# Technical Service Bulletin

<b>Subject:</b>  ABNORMAL NOISE WHEN OPENING POWER LIFTGATE	<b>Bulletin No.:</b> 09-009/23
	<b>Last Issued :</b> 02/07/2023

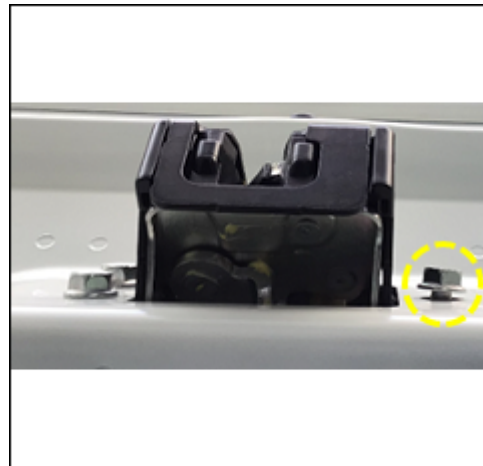
**NOTE:** This Service Information is only applicable if the liftgate latch has the following conditions:

The latch bracket is damaged

The bolt is loose

1. Verify the customer concern.
2. Replace the latch and bolts with the improved parts listed in the parts section following the instructions in MGSS:
  - **CX-30: LIFTGATE LATCH AND LOCK ACTUATOR REMOVAL/INSTALLATION**
  - **CX-50: LIFTGATE LATCH AND LOCK ACTUATOR REMOVAL/INSTALLATION**
3. Verify the repair by confirming the noise has been eliminated.
